Early Design Guidance 2
8.28.2019
3033617-EG
725 Yesler Way

SECTION 03 / EDG-1 Summary of Board Guidance

Summary of Board Guidance

Service Access

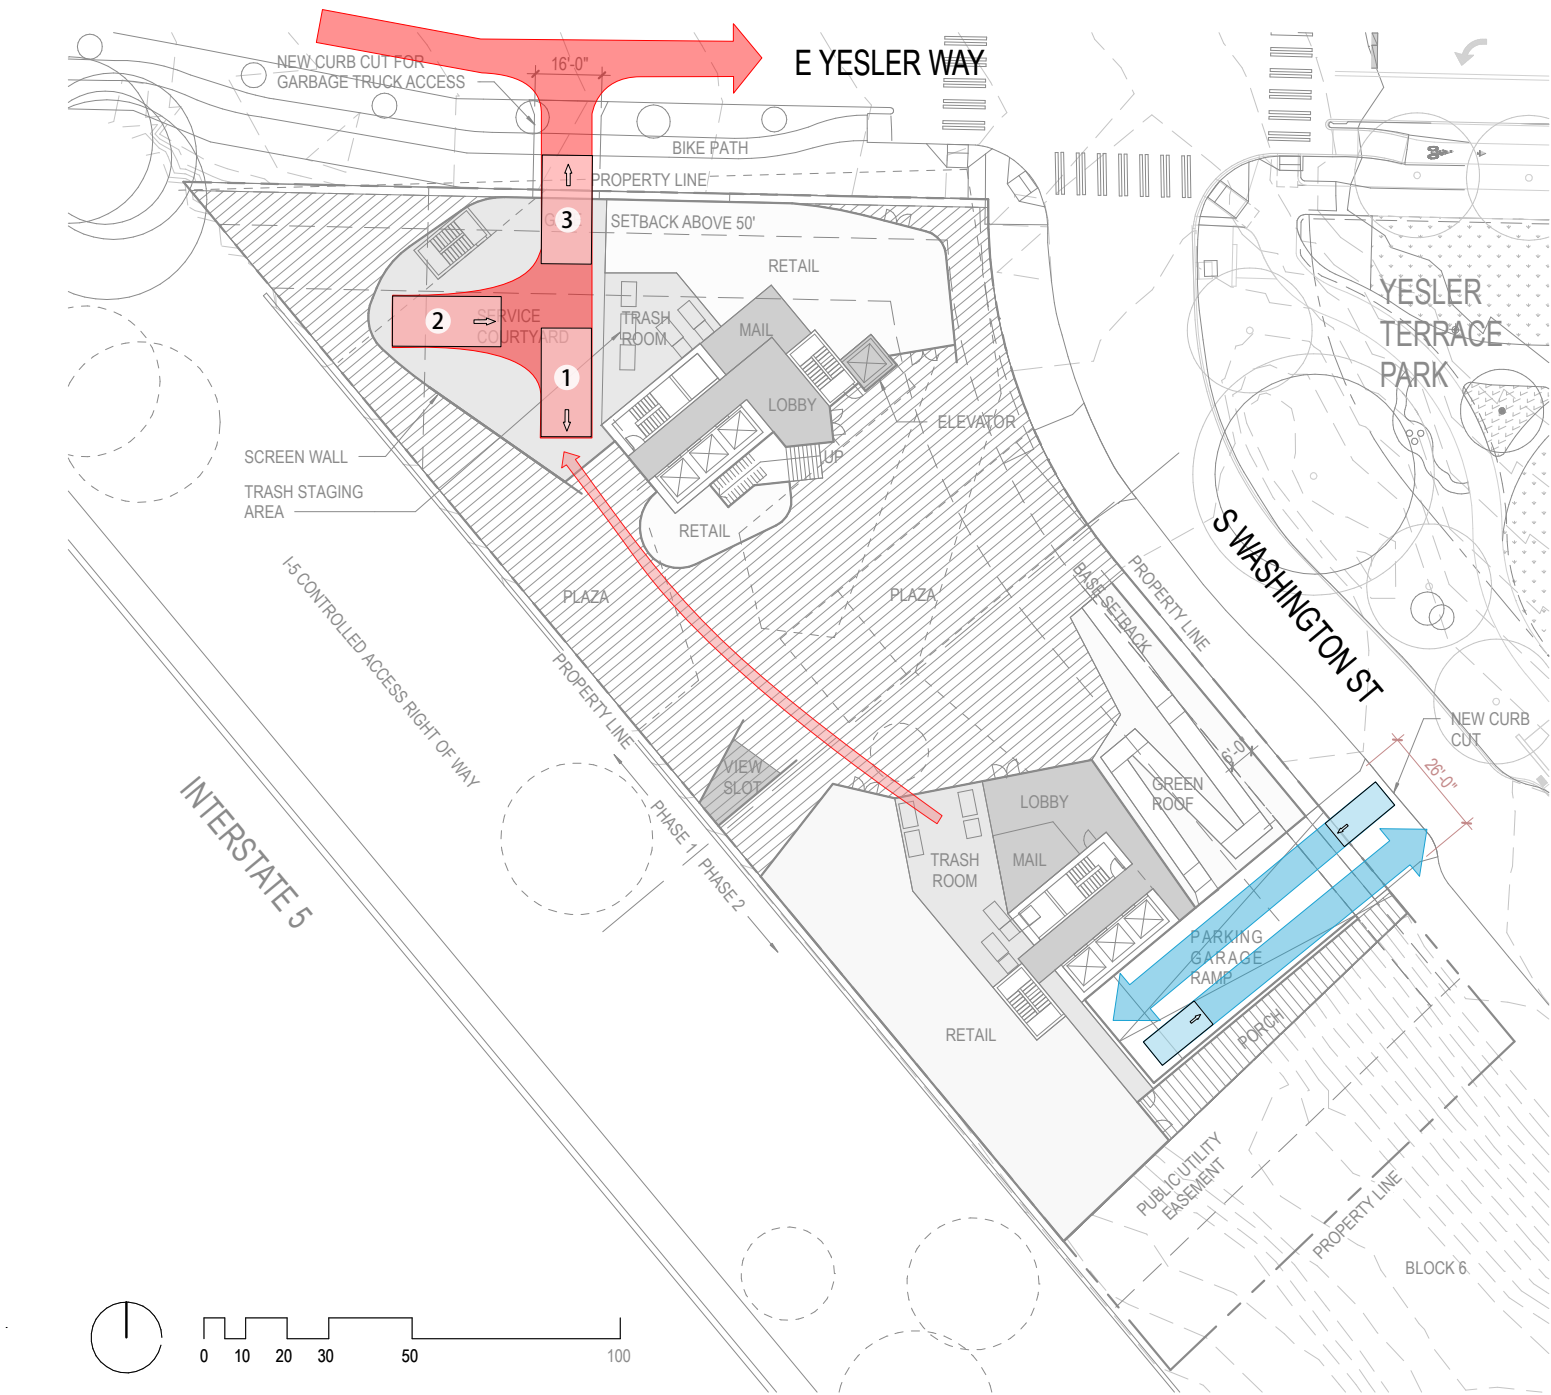
The Board requested clarification on how the service entry from Yesler Way will be thoughtfully designed, pedestrian friendly and safe.

The service access from Yesler will be separated from the pedestrian plaza and circulation spaces with screen walls and a gate to ensure safety.

Response 3 : Stormwater Strategy

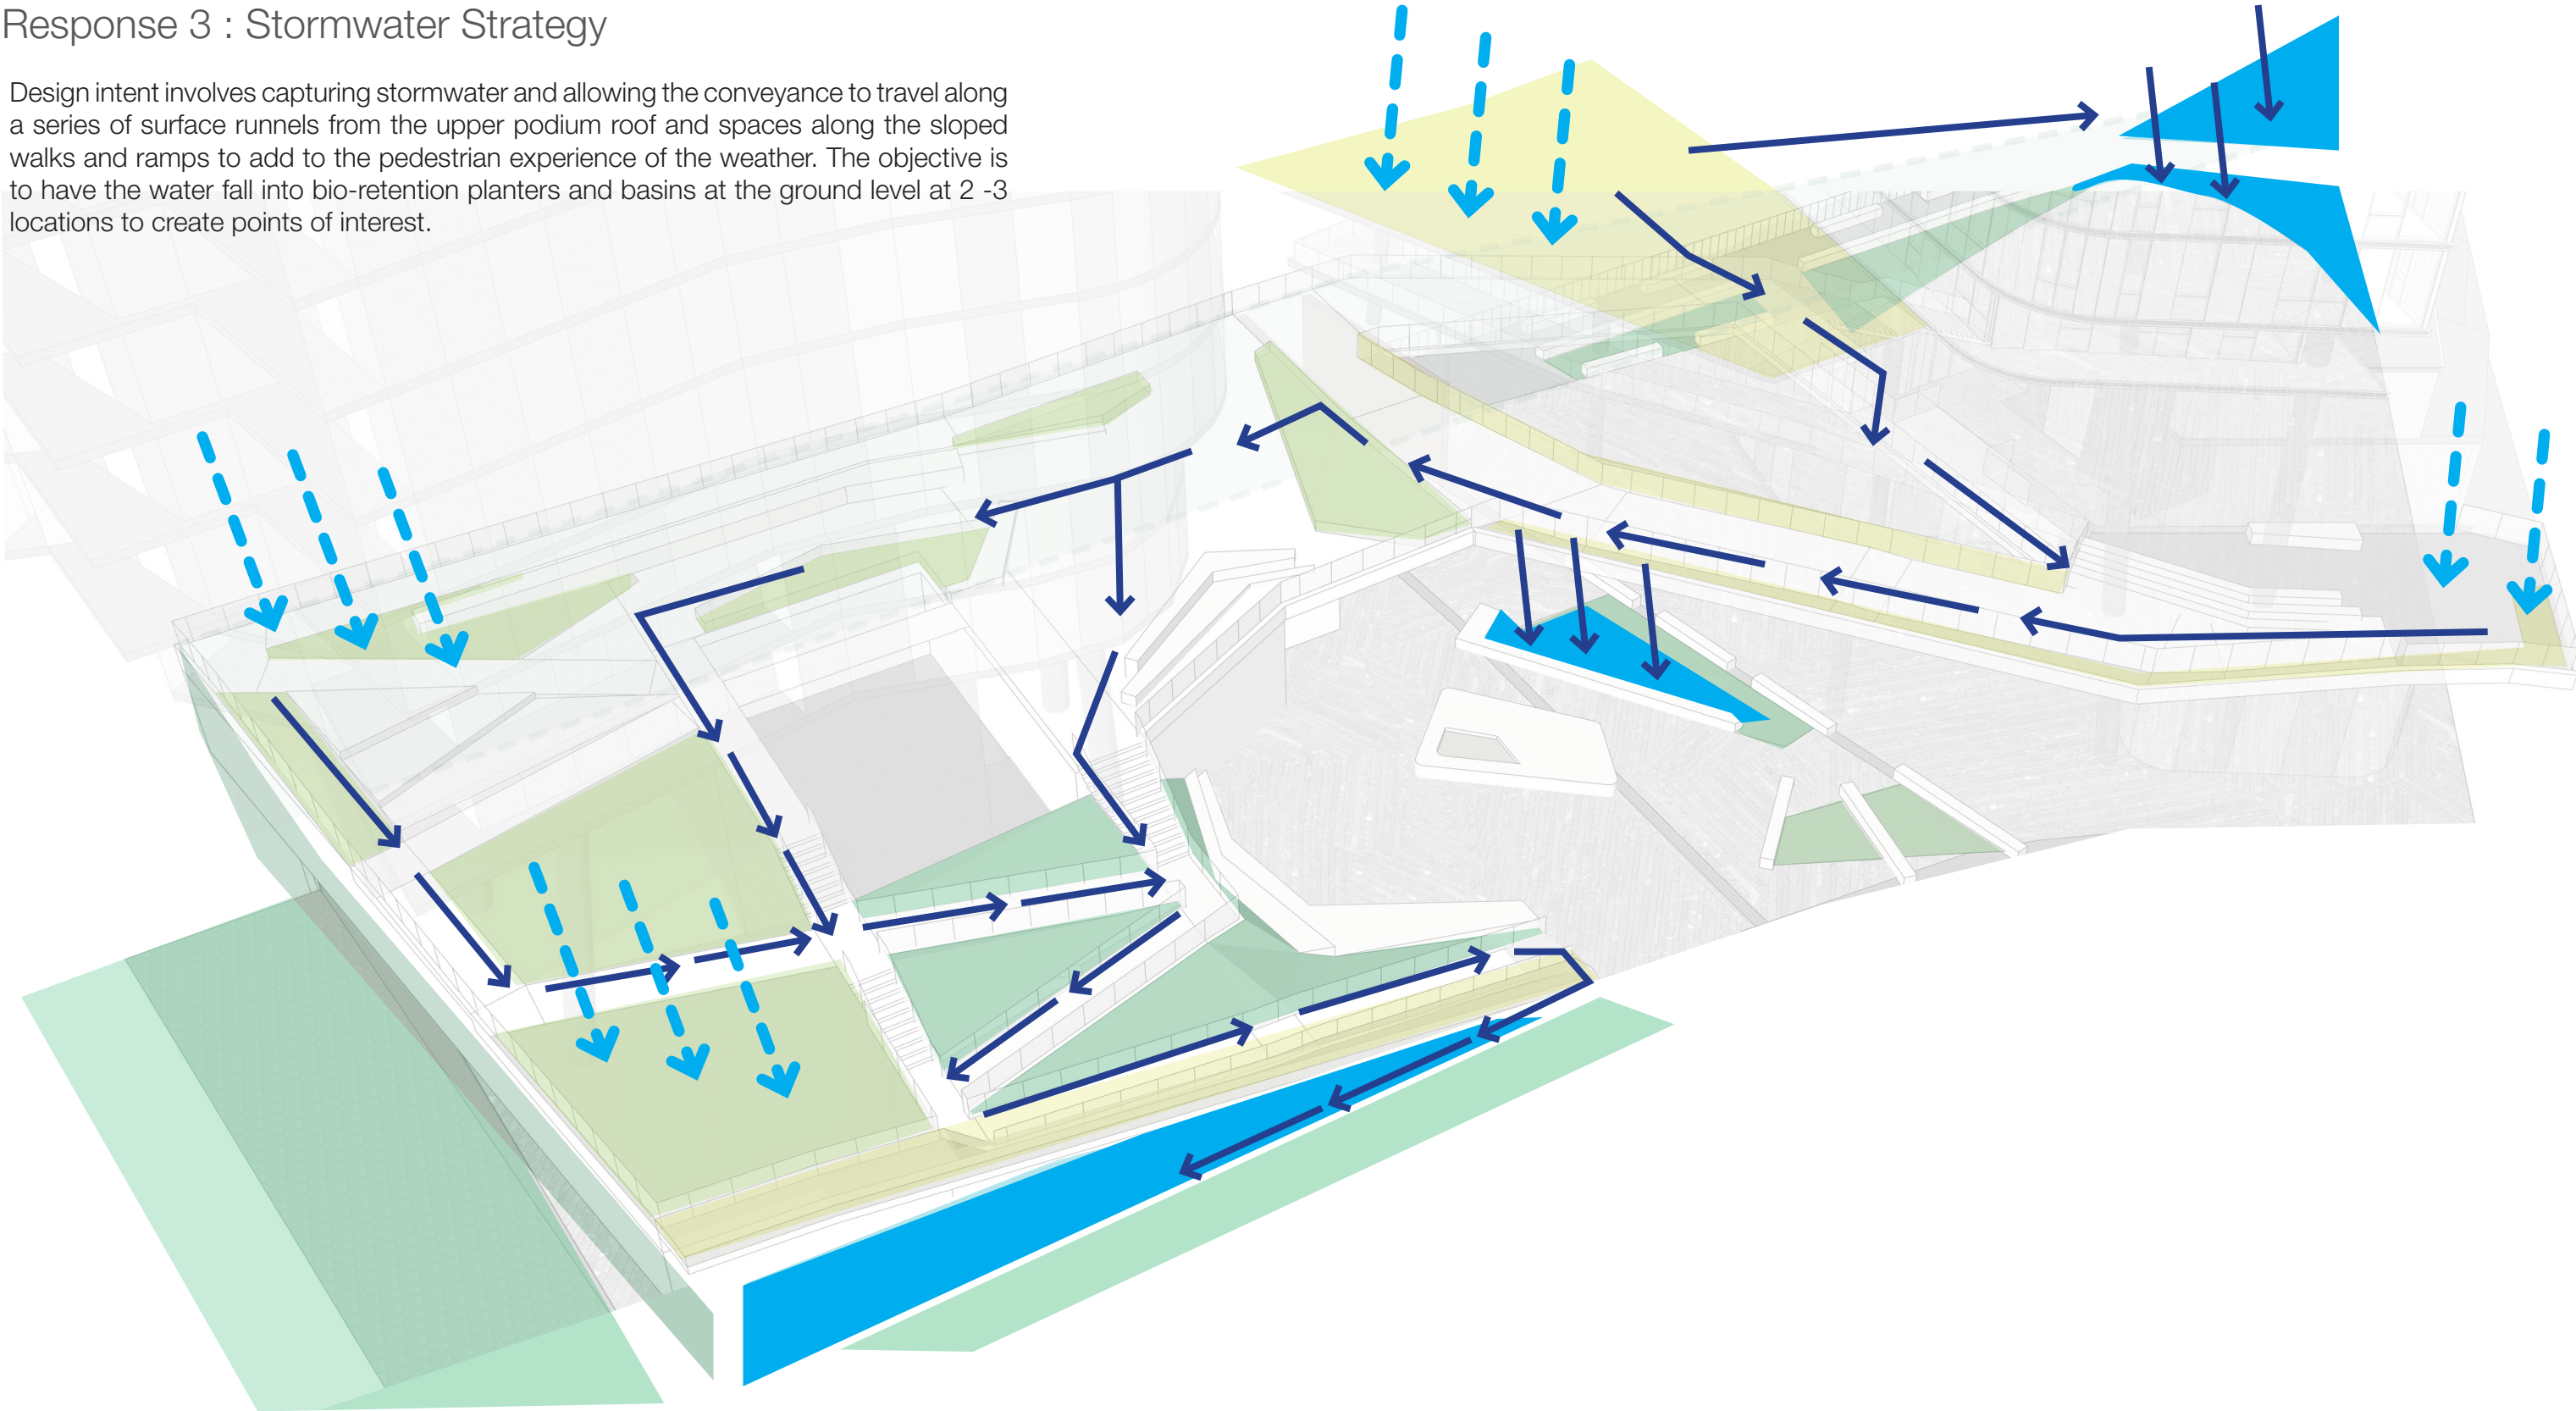
- 3. Considering the movement of water and stormwater inspired by the topological and hydrological conditions.
- 4. Being thoughtful of service entry design from Yesler Way, and clarifying how the space will be pedestrian friendly and safe.

- 3. The design intends to use the site topography created by the ramps and elevated open spaces to capture, convey, and openly express the hydrologic cycle. Visitors will be able to experience rain events, and the subsequent run-off, throughout the site. Some expressions of water will be bold and highly visible, while other water events will be subtle and become part of the series of discoveries within the site.

Design intent involves capturing stormwater and allowing the conveyance to travel along a series of surface runnels from the upper podium roof and spaces along the sloped walks and ramps to add to the pedestrian experience of the weather. The objective is to have the water fall into bio-retention planters and basins at the ground level at 2 -3 locations to create points of interest.

Response 7 : Plant Palette

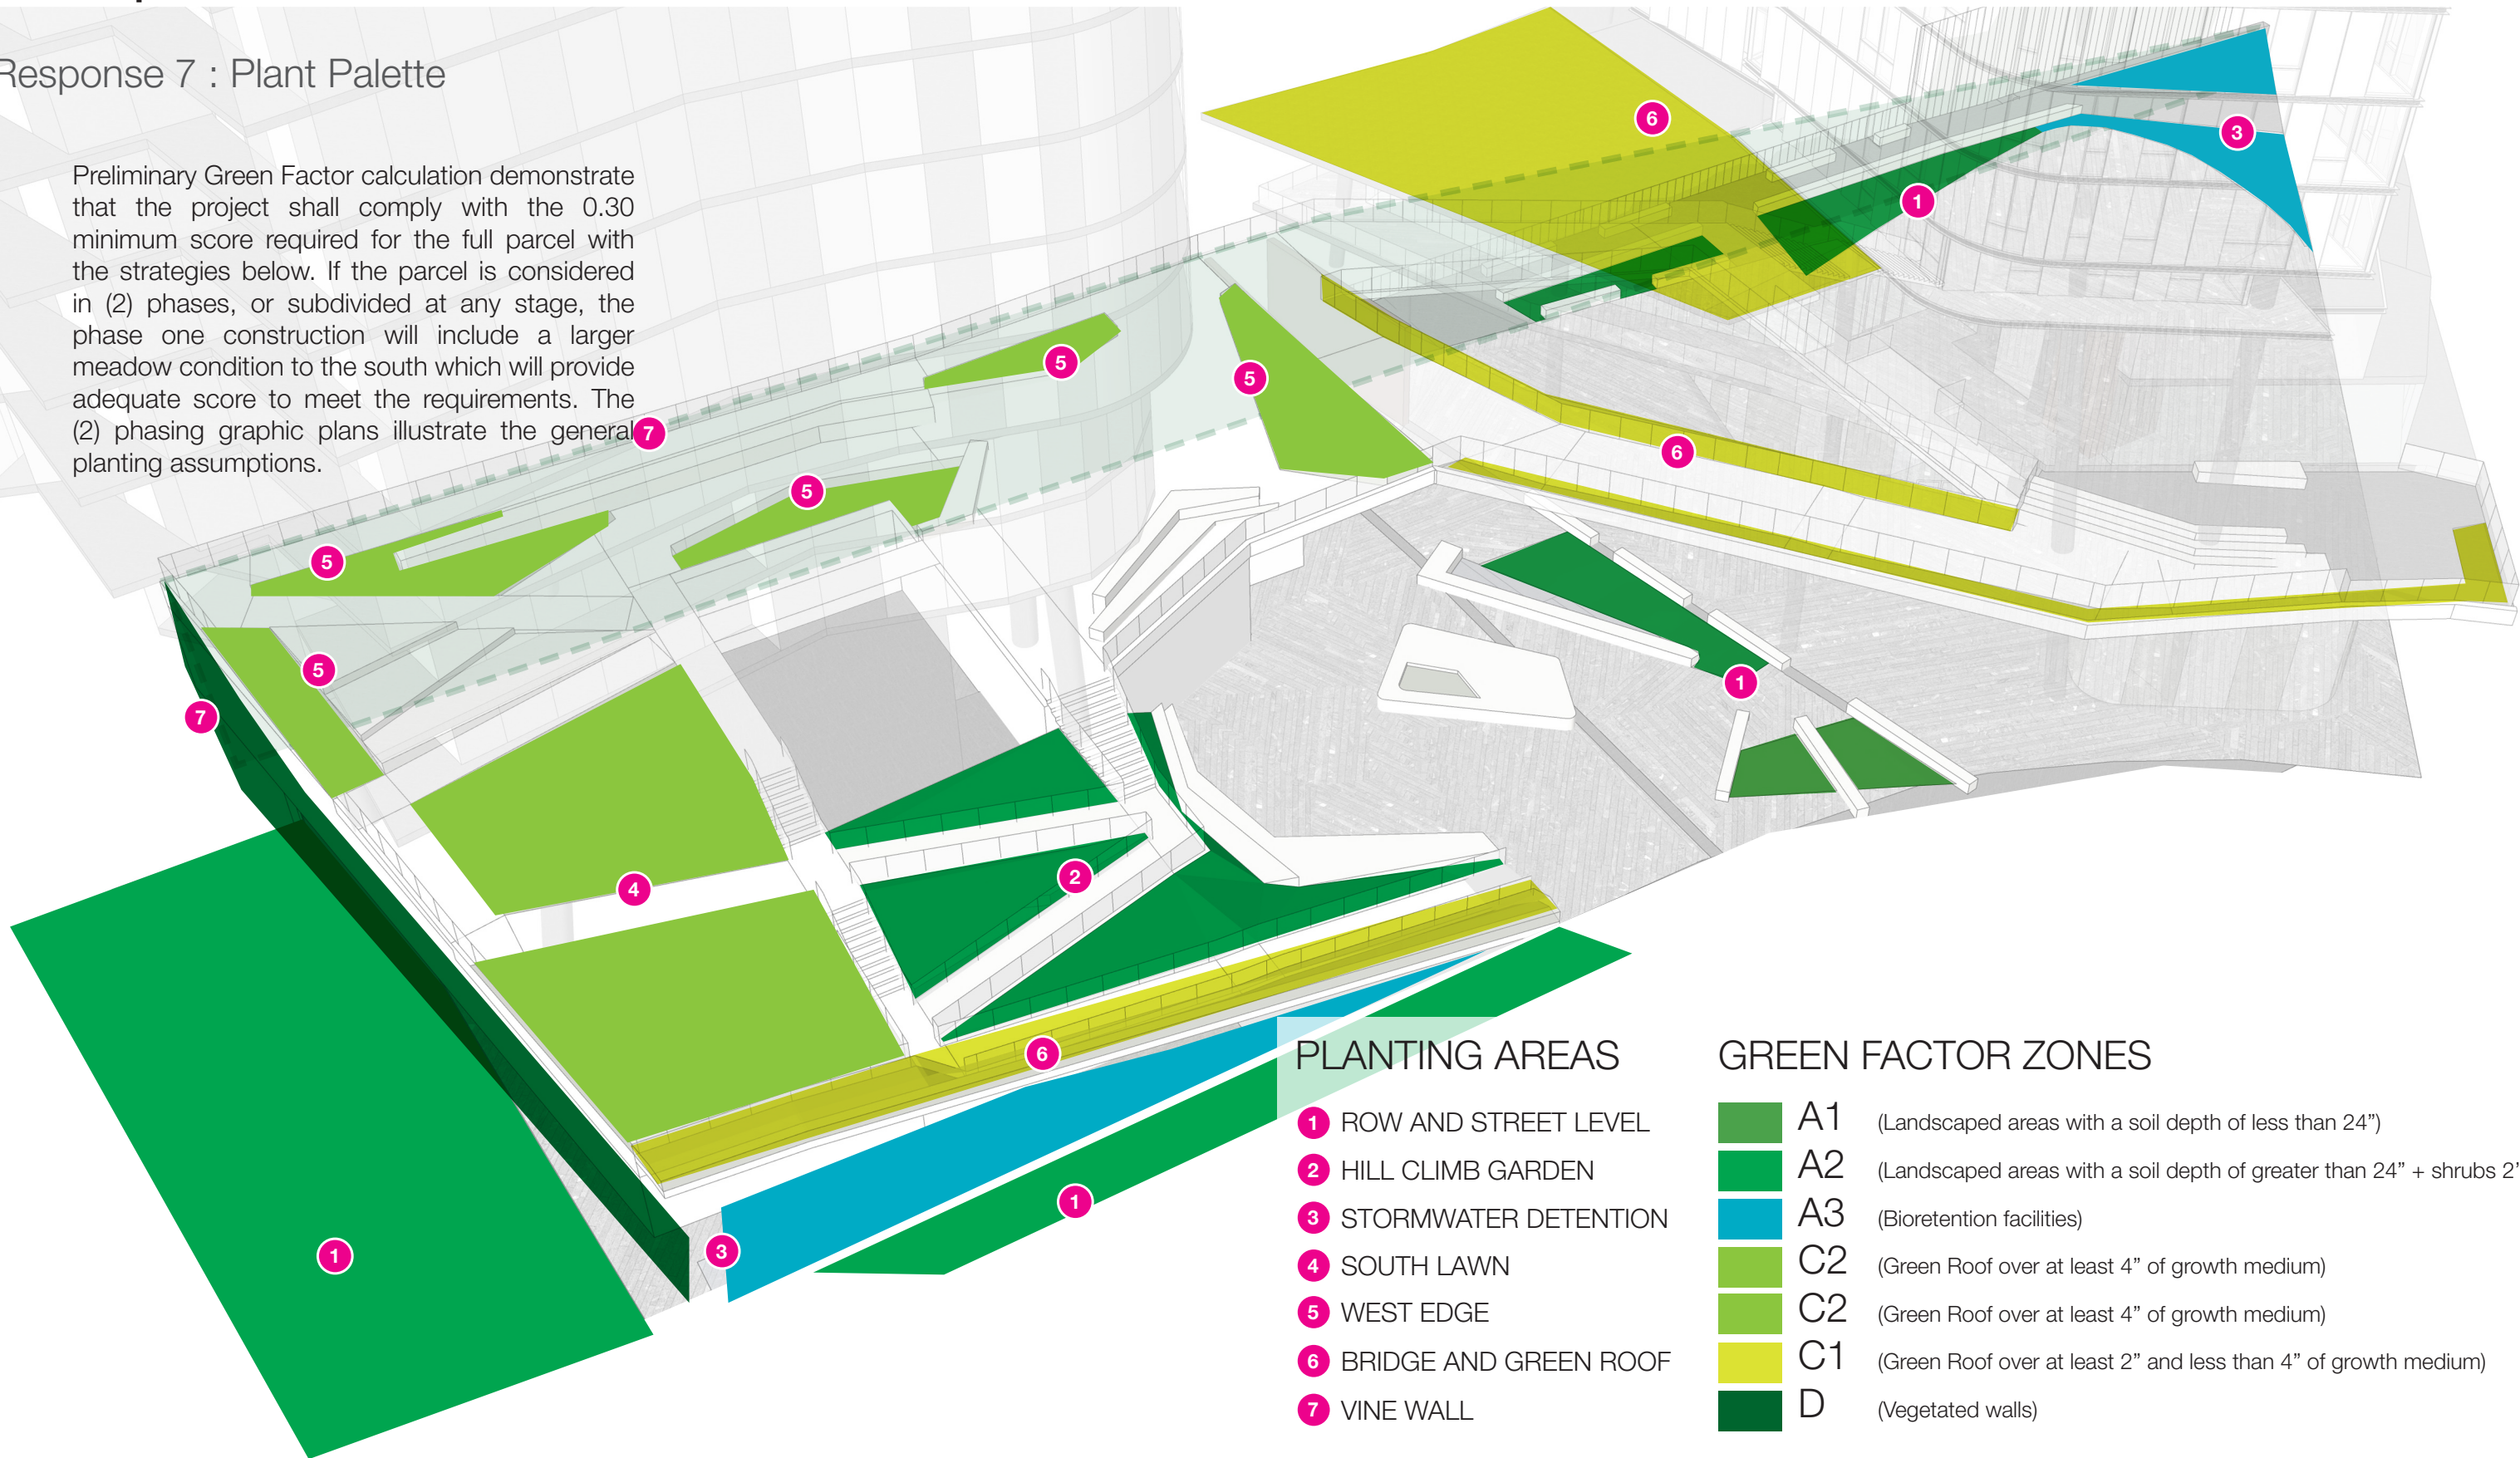
- 7. How the project will pull in plant palette from the park.
- 8. Considering pedestrian circulation from the park.

- 7. The design intention is to differentiate the project from the park with unique plant selection appropriate for a landscaped roof within a more urban space.

Preliminary Green Factor calculation demonstrate that the project shall comply with the 0.30 minimum score required for the full parcel with the strategies below. If the parcel is considered in (2) phases, or subdivided at any stage, the phase one construction will include a larger meadow condition to the south which will provide adequate score to meet the requirements. The (2) phasing graphic plans illustrate the general planting assumptions.

Materials and Façade Development

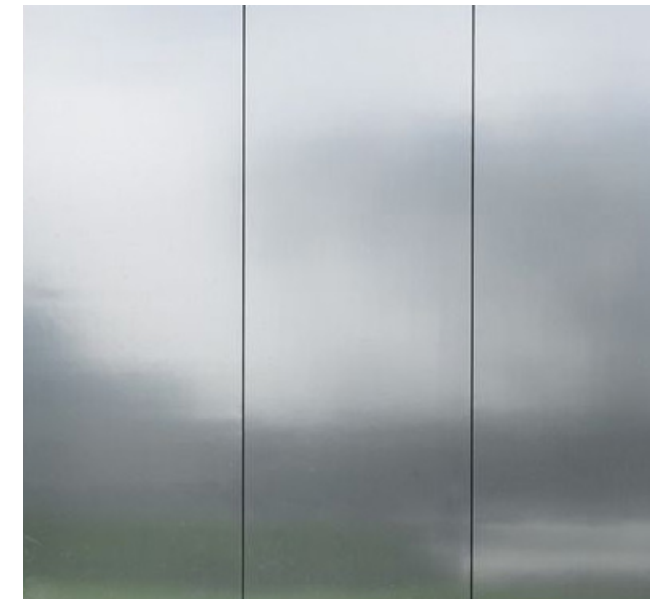
The board requested more information regarding:

- 1. Soffit treatment
- 2. Maintaining thickness of the floor expression and exposure
- 3. High quality materials
- 4. Consider how can materials further soften and warm the expression of the tower
- 5. Clarify design strategies related to the garage entry along South Washington Street

- 1. The large podium soffits create large façades visible from I-5 while defining the character of the plaza spaces. As such, material selection will be thoughtful with a desire to create a varied and dynamic experience that engages natural phenomenon, in particular changing daylight conditions.

- 2. As the window wall facade is developed, the expressed floor edges will be studied.
- 3. Per the Yesler Terrace Design Guidelines, high quality materials such as concrete, metal, stone and glass will be used throughout the project.

- 4. As the window wall façades are developed, use of a variety of glass types and metal panels finishes will be explored to create dynamic surfaces while establishing a residential scale for the project.

- 5. Shifting the parking garage entrance to the south conceals the entrance below the ramping green room. The adjacent walls and soffit surfaces are an opportunity to enrich the pedestrian experience through special durable finishes.
